WORKSHOP AGENDA

Planning Commission

September 16, 2025 @ 5:30 PM

2 CONSTRUCTION ENTRANCE
SCALE: N.T.S.

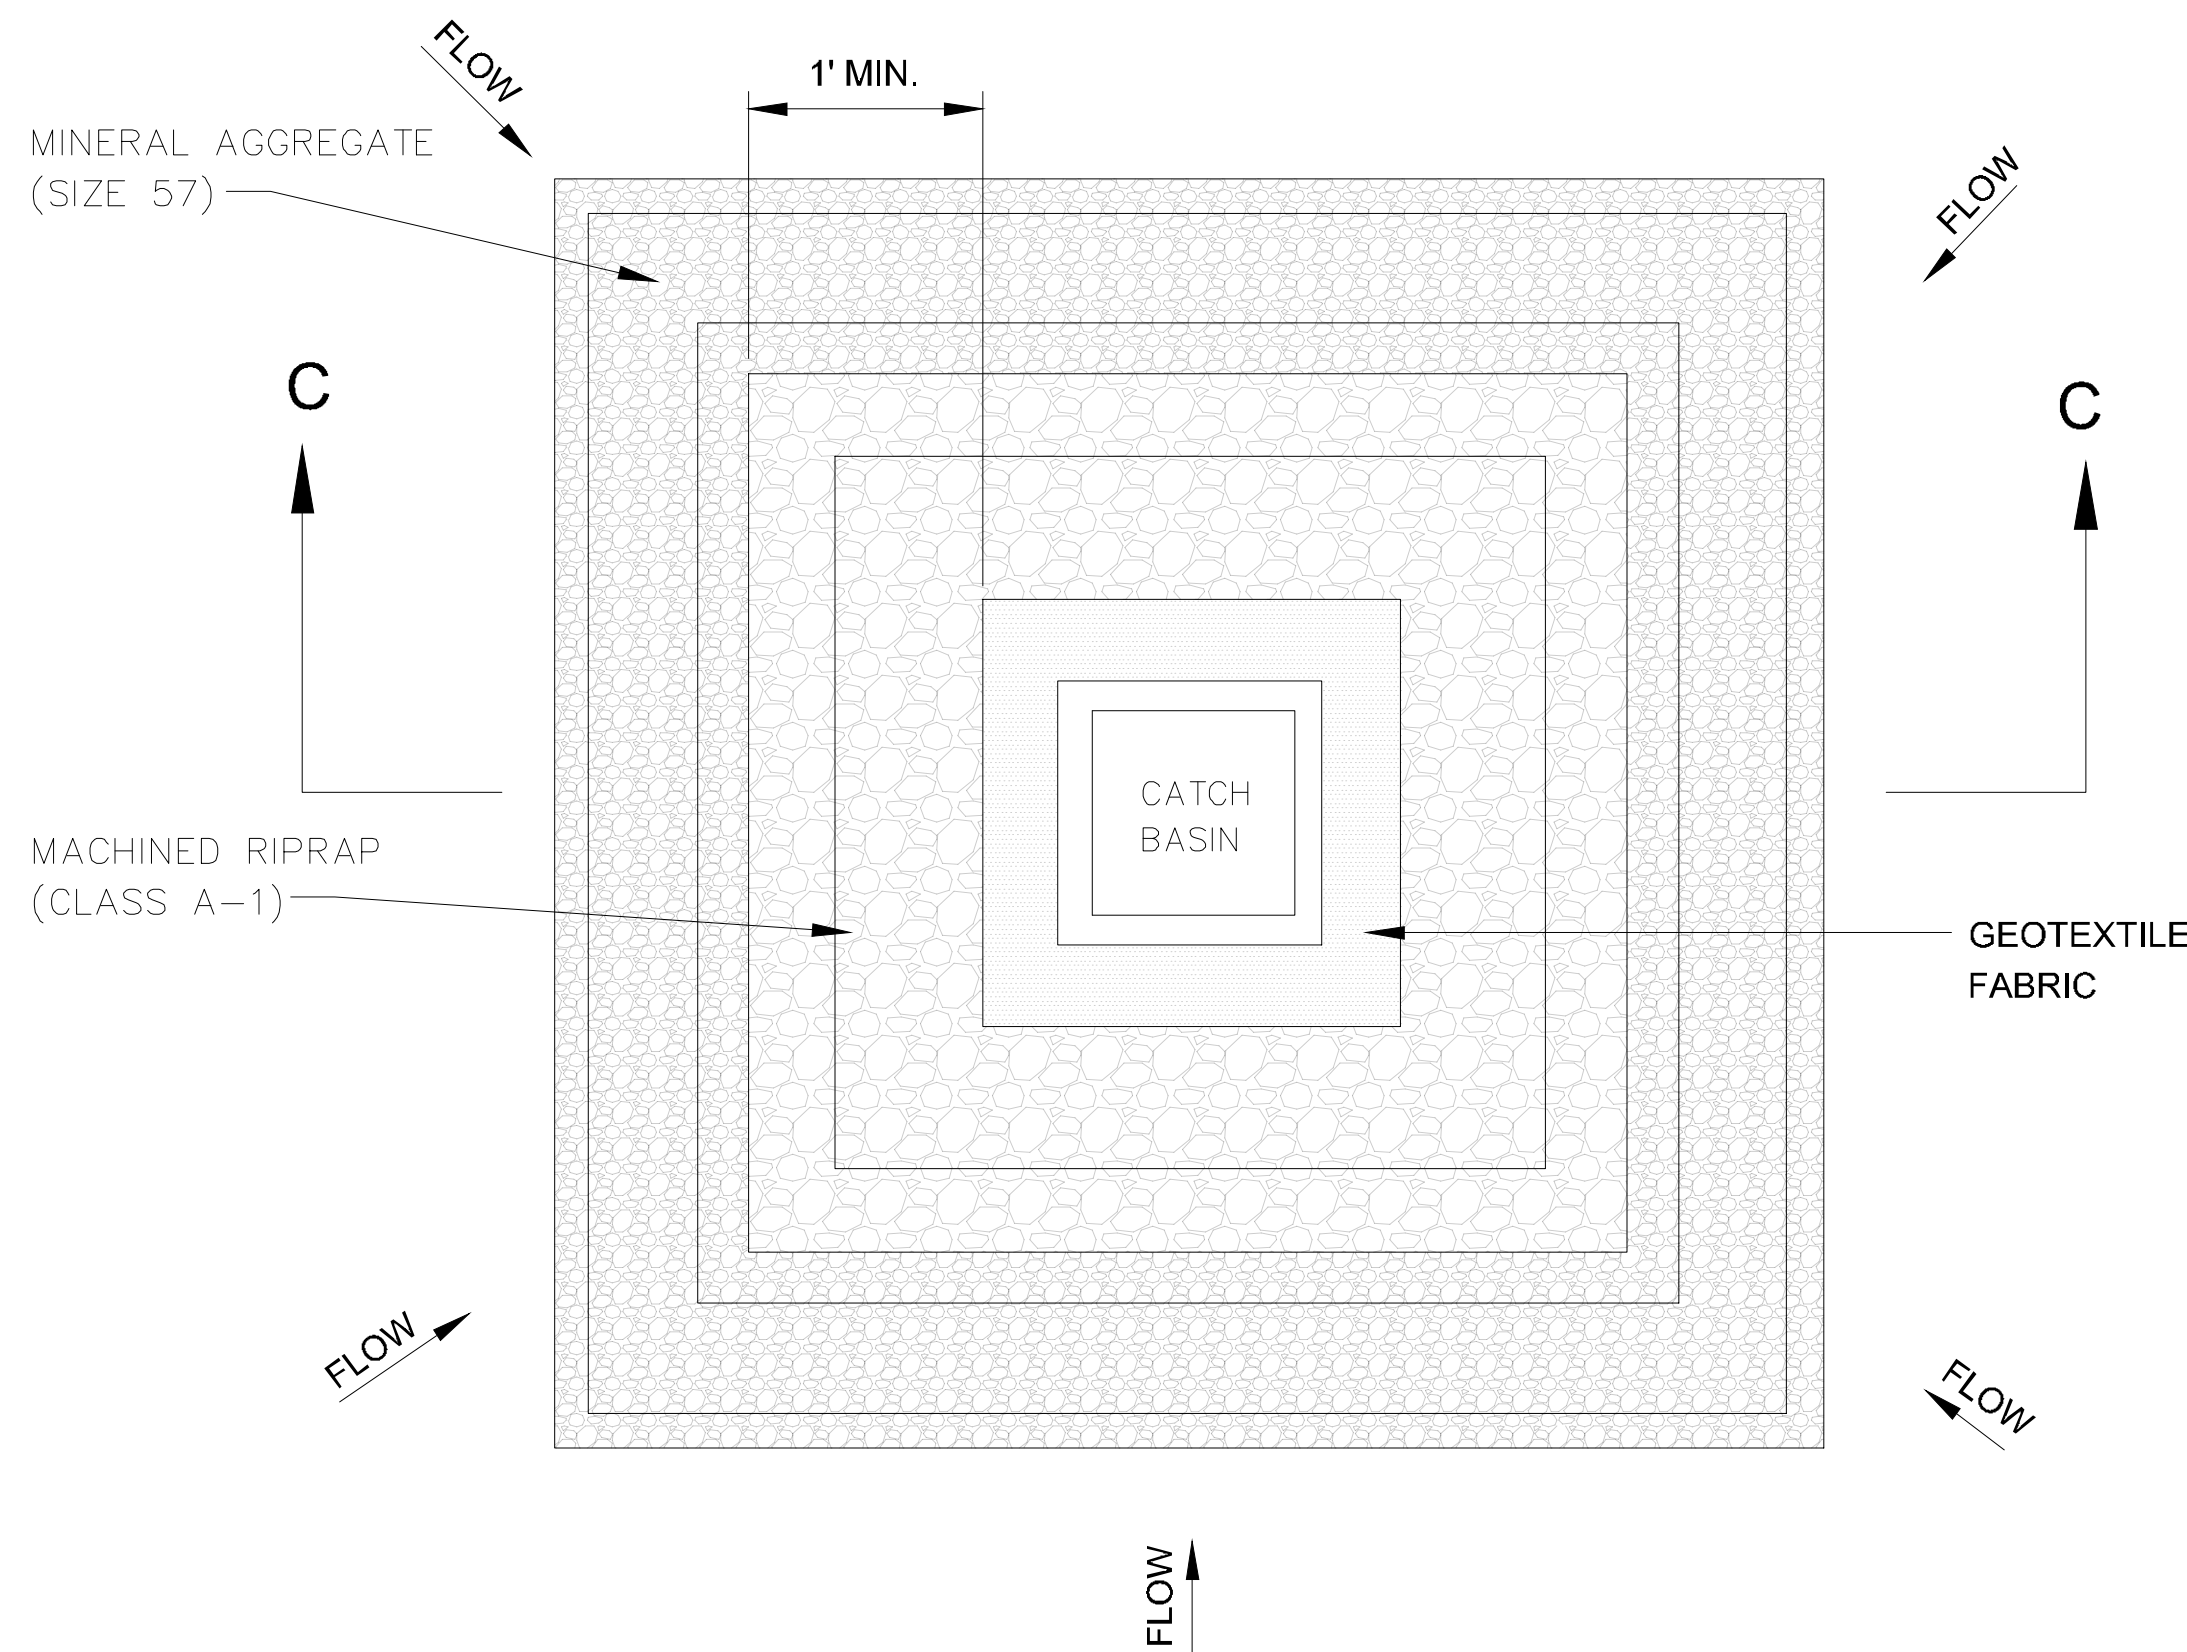
5. (Sheet C-7.3) Modify detail 2 "Construction Entrance" to account for the fact that the entrance is shown placed on top of existing asphalt.
6. (Sheet C-6.1) The dumpster screen is proposed to be exposed CMU with a wooden gate. The Planning Commission will review that proposal against requirements of the Murfreesboro Road Overlay District.

SHEET NO. C1.01

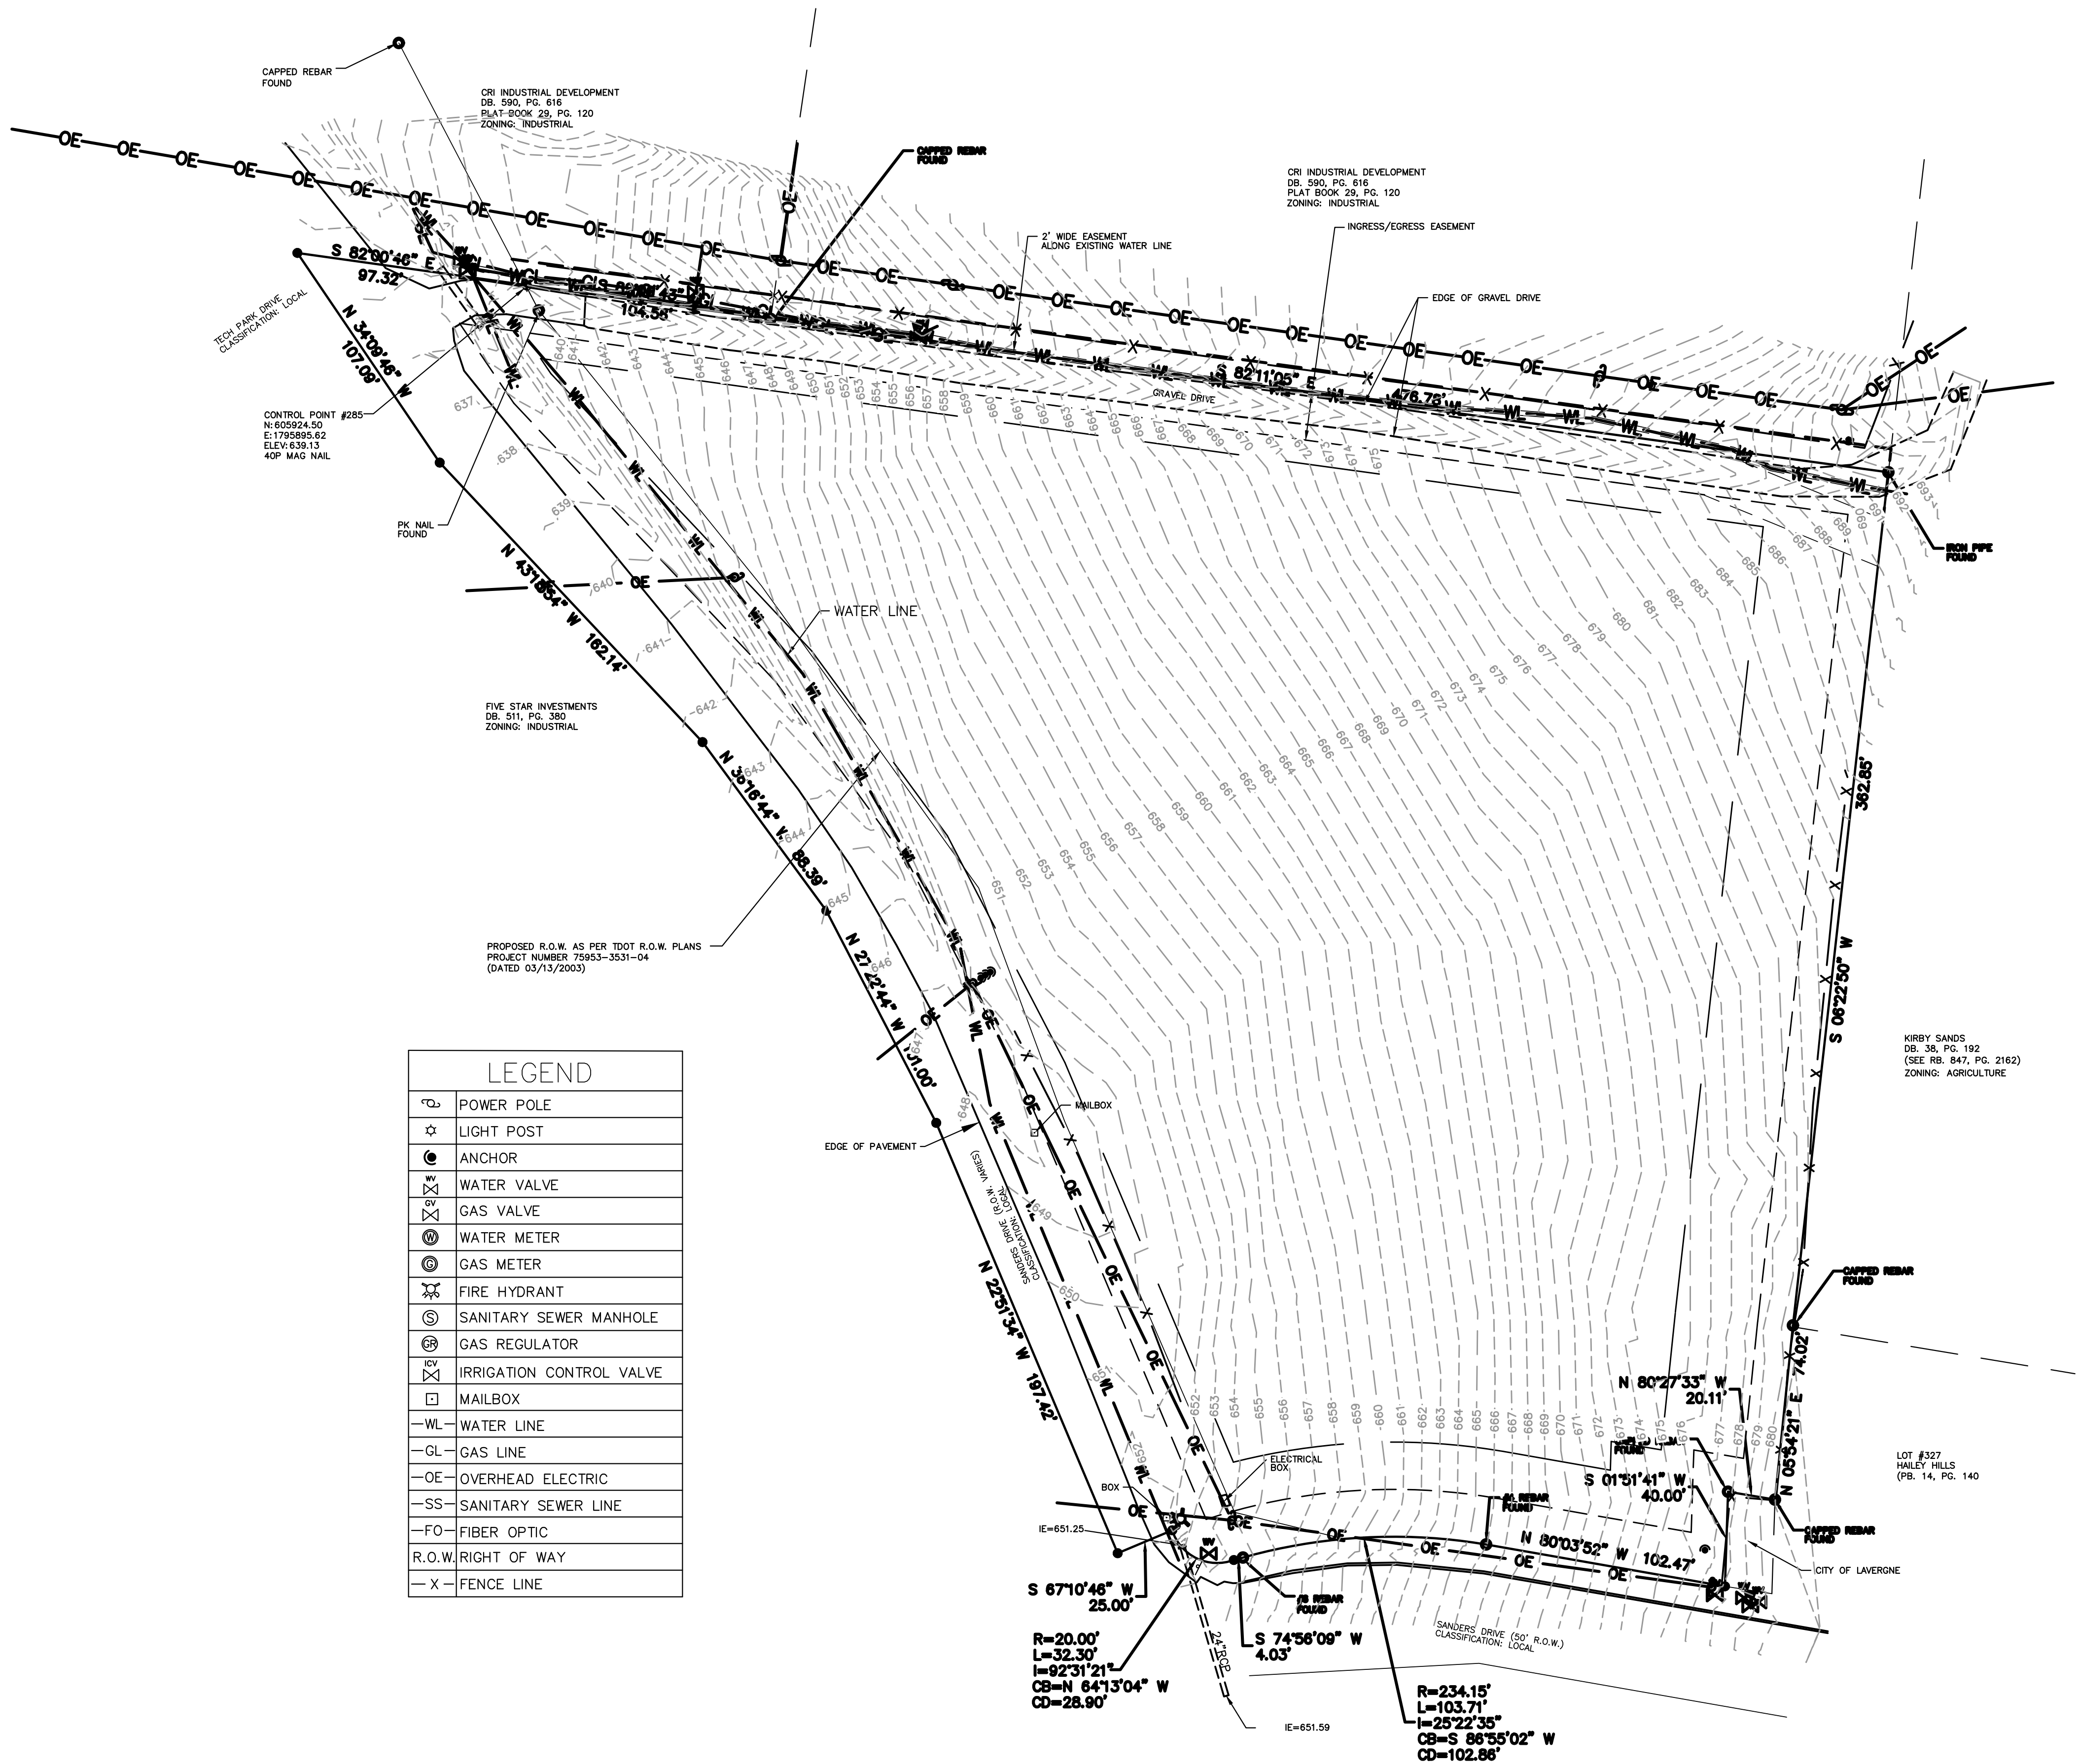
1. (Sheet C1.01) Staff recommends that applicant dedicate additional Public Utility and Drainage Easement (PUDE) as described in the Utilities section below.

2. (Sheet C1.01) Add DB 291 PG 475 for 2' waterline easement along north boundary.
3. (Sheet C1.01) Staff recommends that applicant dedicate sufficient land for Mason Road right-of-way

4. (Sheet C1.01) Correct scale in title block
5. Provide filled out draft of the Longterm Maintenance Agreement (LTMA) and Longterm Maintenance Plan (LTMP)

6. (Sheet C1.01) Move bearings and distances on north boundary so that they can be read.
7. (Sheet C2.01) Show distances from edge of paving to property boundaries along all boundaries.

10. (Sheet C1.01) Easement width on existing water line is shown as 2'. Show correct easement width.
11. (Sheet C1.01) Show DB and PG for easements.
12. (Sheet C1.01) Correct note where Mason Road is incorrectly labeled as Sanders Road.

13. (Sheet C2.01) Provide concrete pavement section for drive and parking areas
14. (Sheet C1.01) Add DB 593, PG 125 to the access easement
15. While a full traffic study will not be required, please provide traffic generation estimates for the proposed use.

43. (Sheet C1.01) Show tree masses.
44. (Sheet C1.01) Show areas where slopes exceed 12% and show USDA-NRCS soil types for those areas.
45. Provide a Site Profile that runs from their northwest corner of the site running southwest through the building and down to the centerline of Mason Road.
